CONSTRUCTION DOCUMENTS

FALCON MARKETPLACE

SF-19-001

75% SUBMITTAL 12-20-18

POND #3 INFLOW AND OUTFLOW

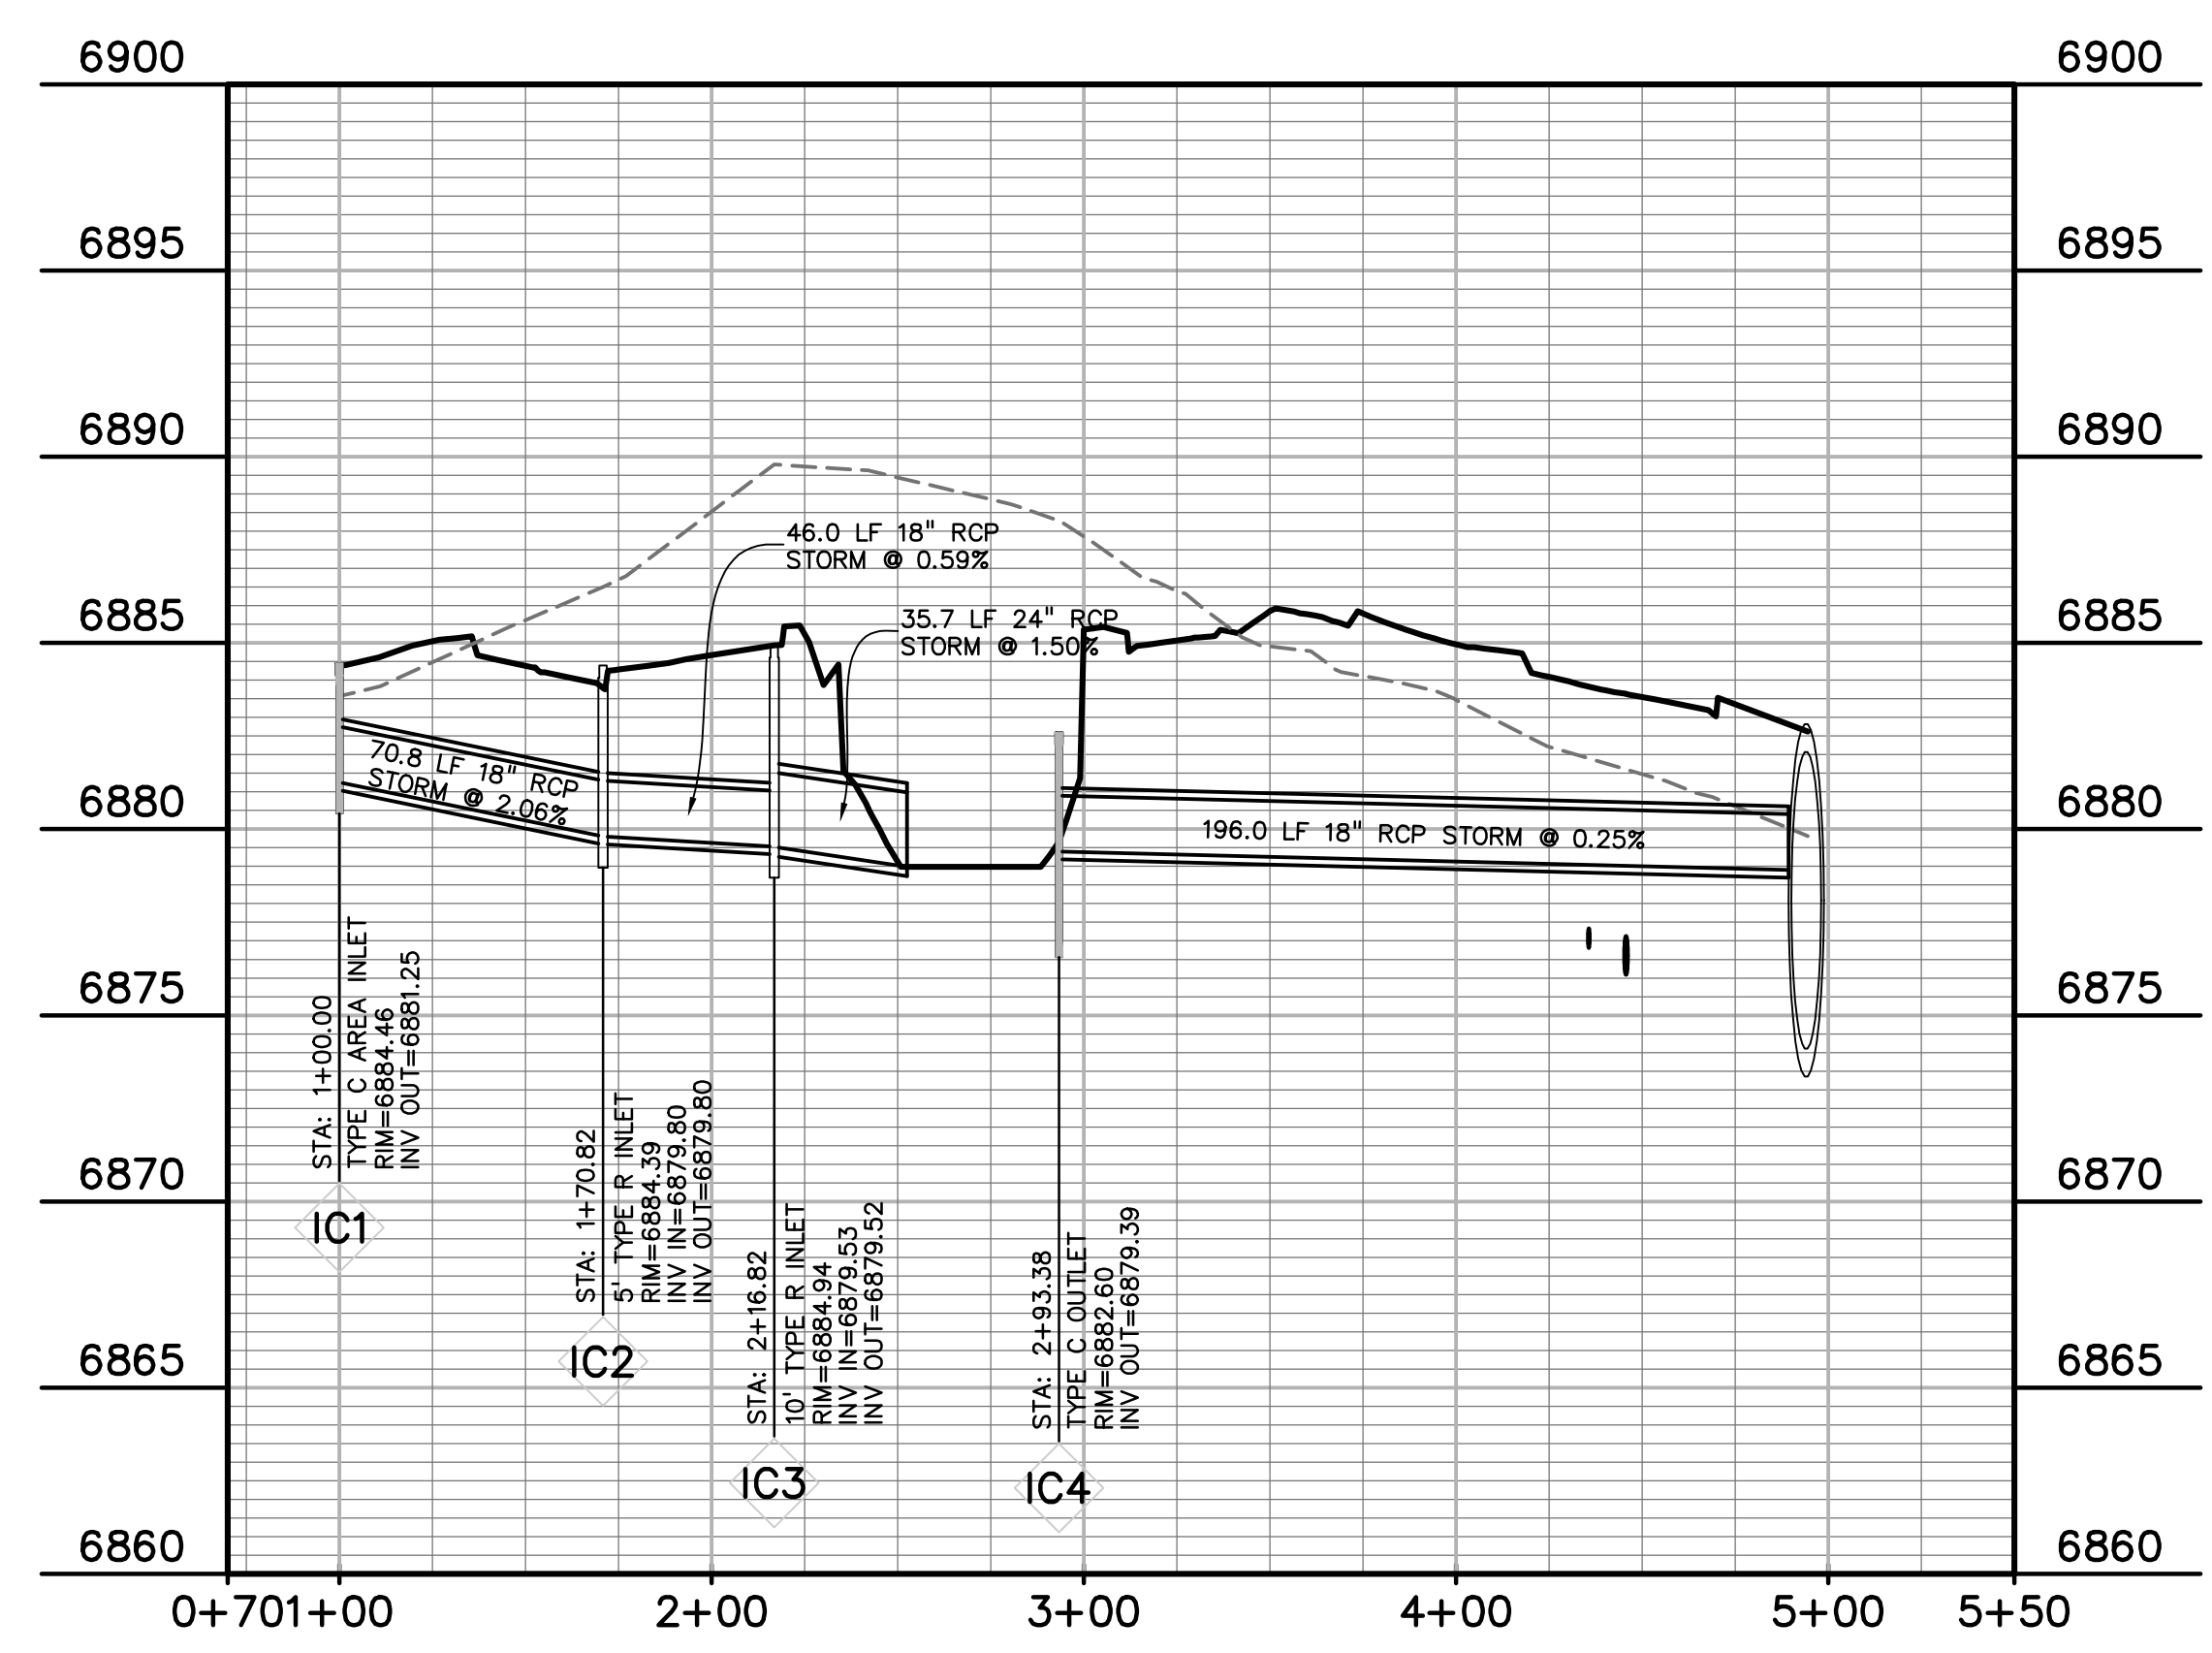
Provide complete plans and details.

**STORM SEWER
PLAN &
PROFILE**

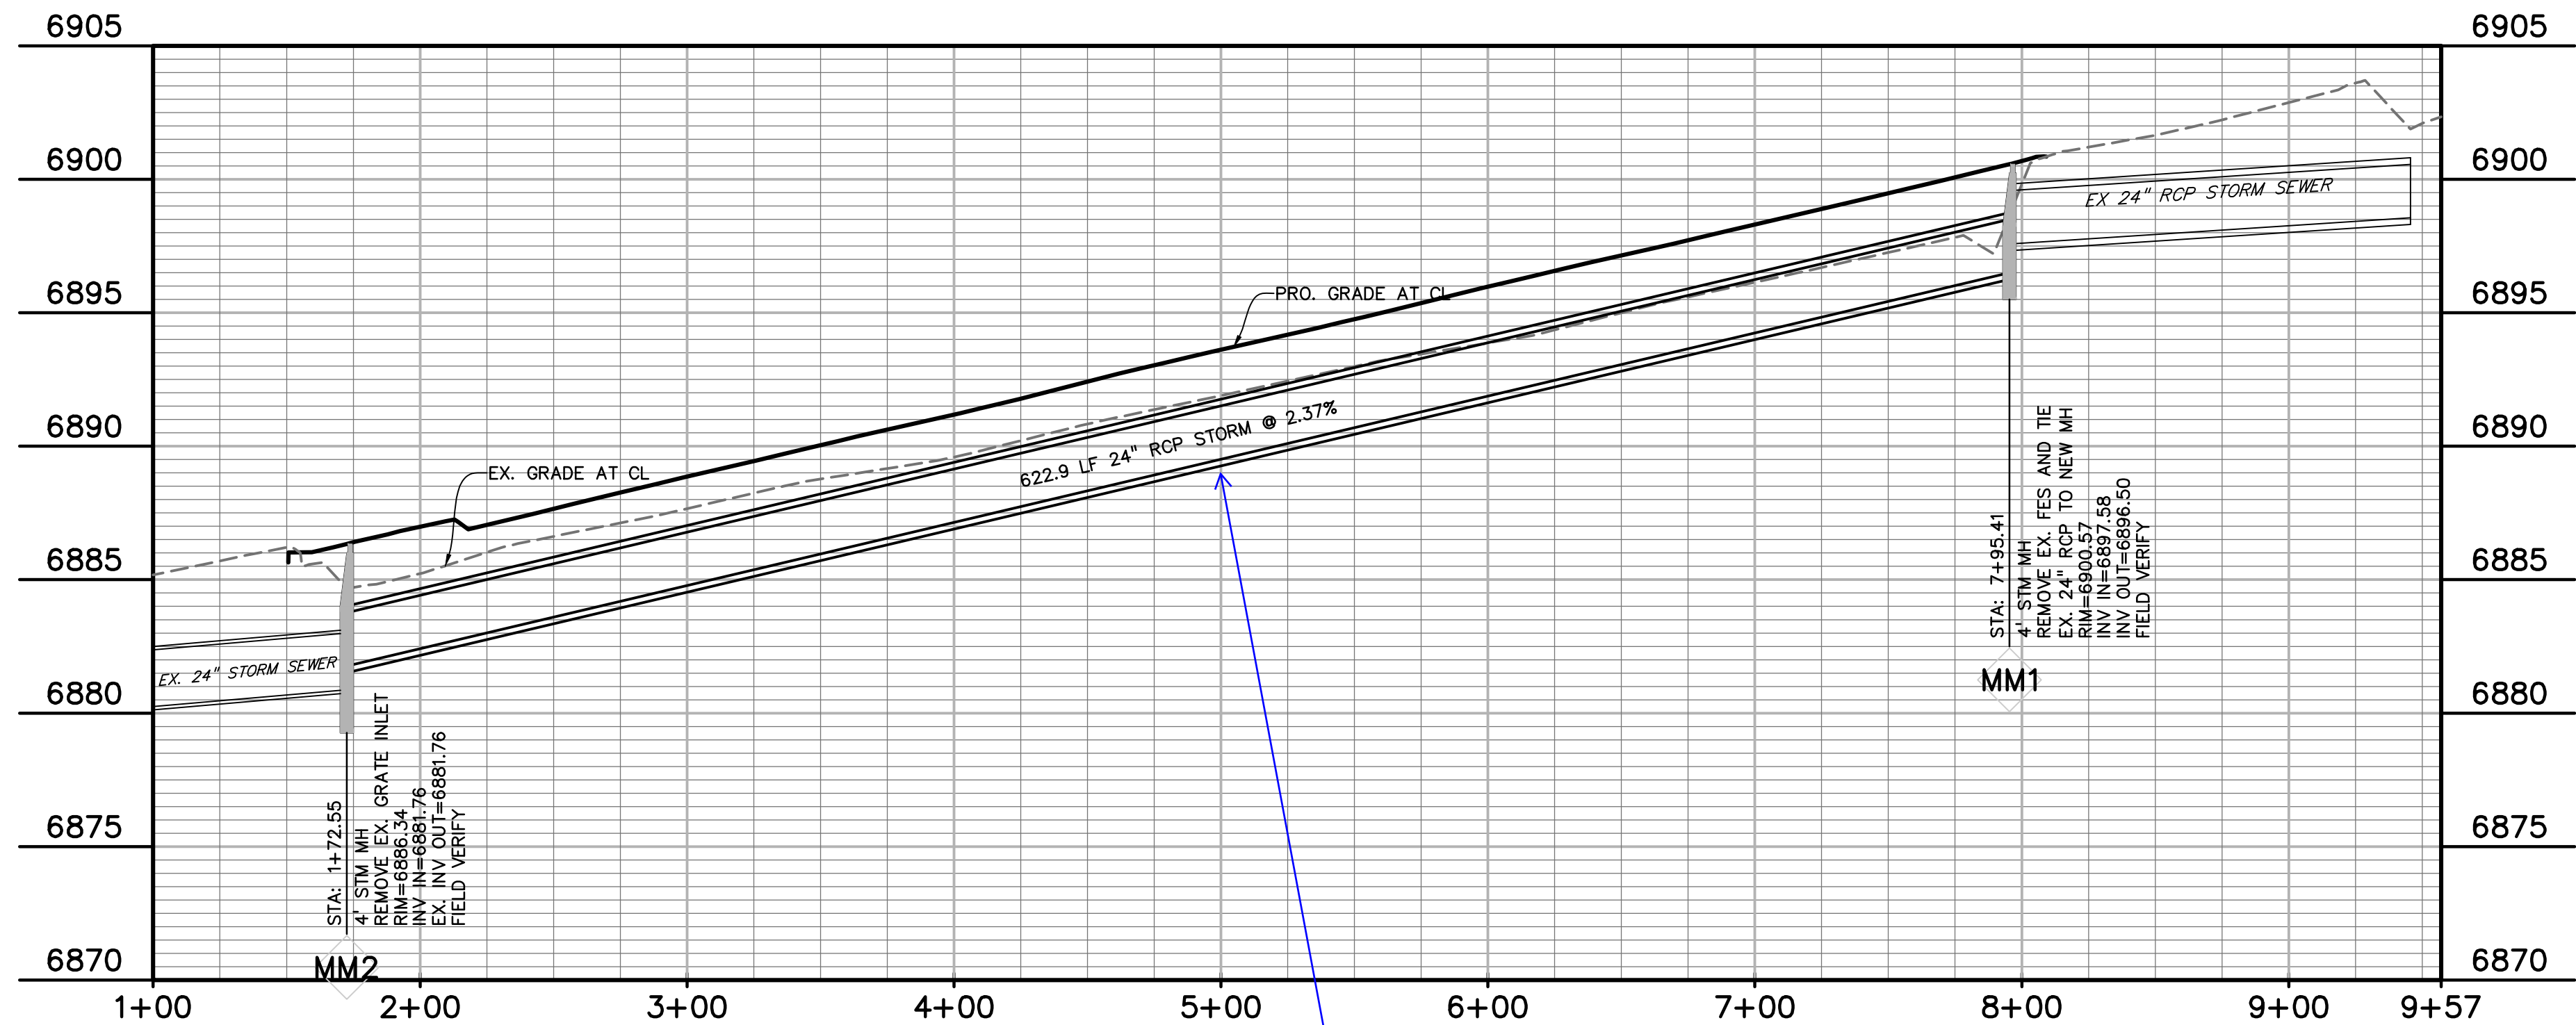
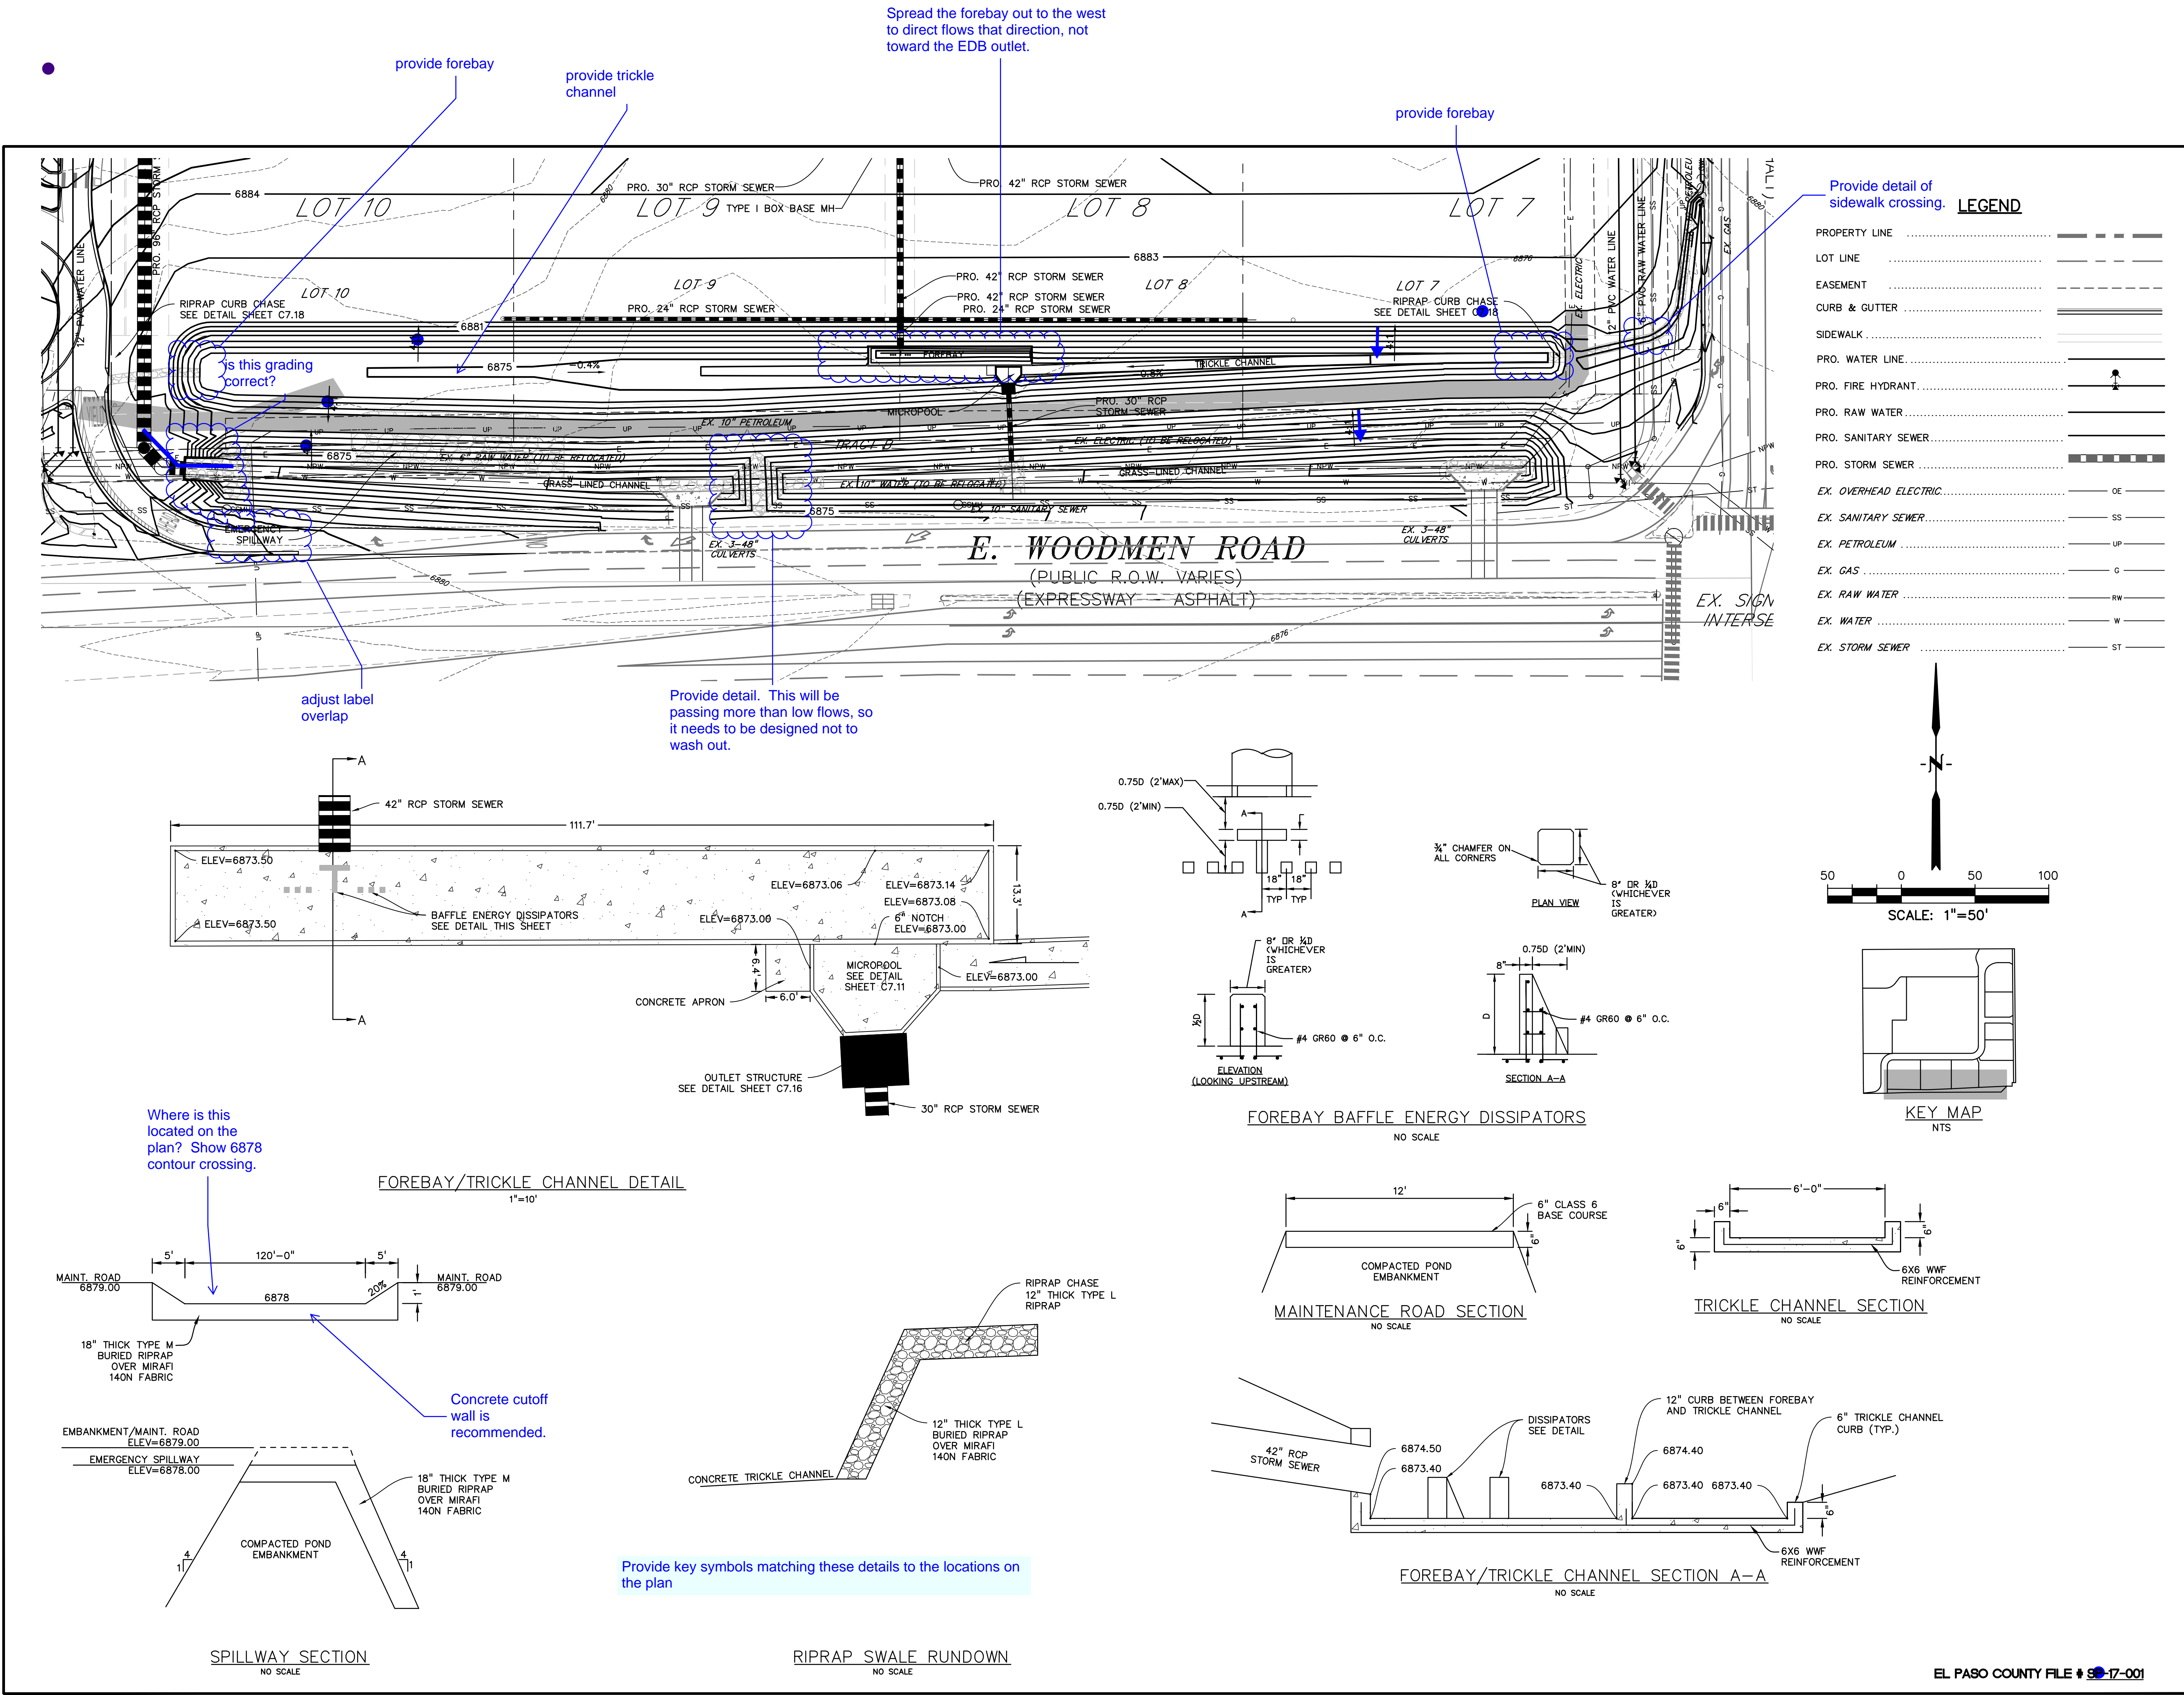
Add manhole?
